Project: 424C01 Cornish Library & Community Center
226 NH-120
Cornish Flat, New Hampshire 03746

RFI #6: Basement Wall Openings

1 FOUNDATION PLAN
3/16" = 1'-0"

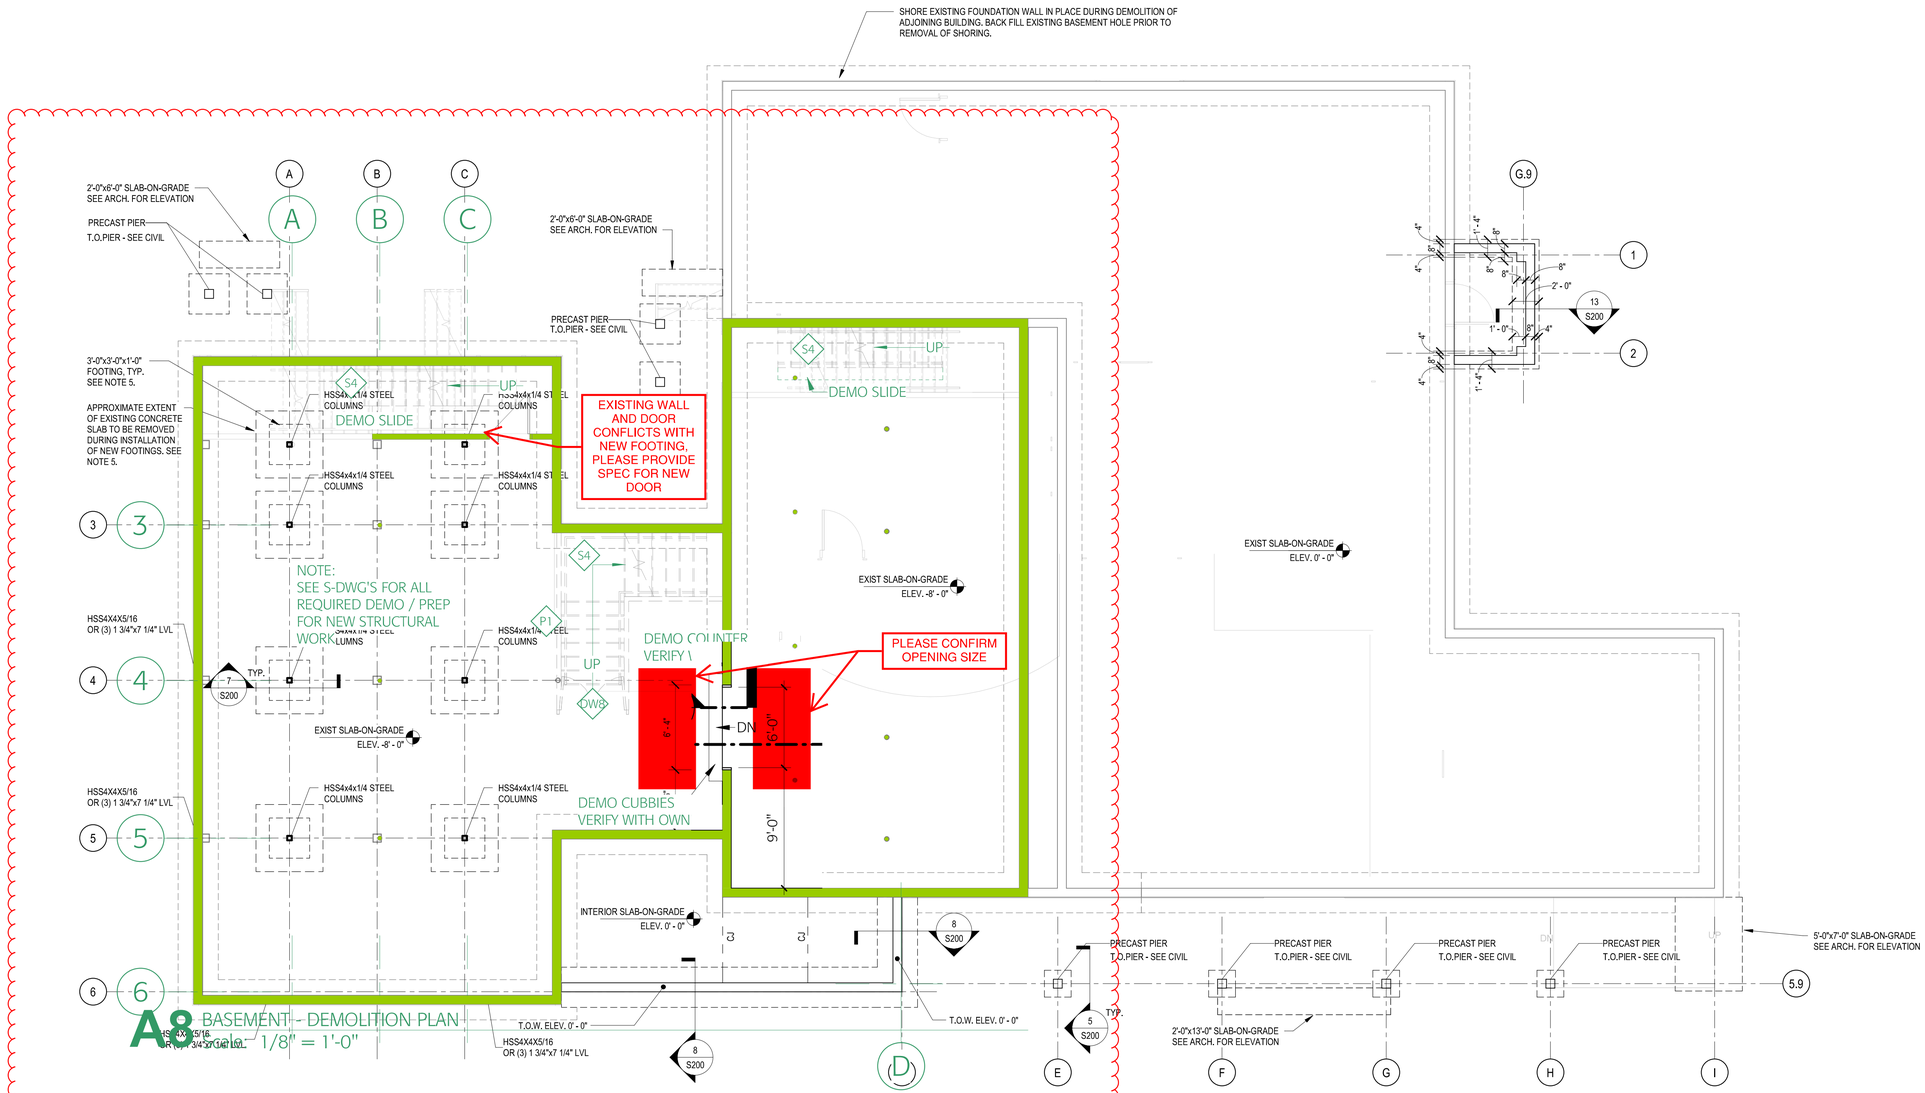
1) Please note that the existing door noted to remain conflicts with the new footing location and had to be removed.

2) Confirm the intended new opening width between the two basements. The structural and architectural note different opening sizes.

Please review the attached markup.

1. For the door that needed to be removed for the new footing- please salvage and reuse. Please verify the door is a 1 hour rated door which is required. If it is not rated, we will issue a bulletin for a new door and frame.

Door opening to be 6'-0" Wide Clear
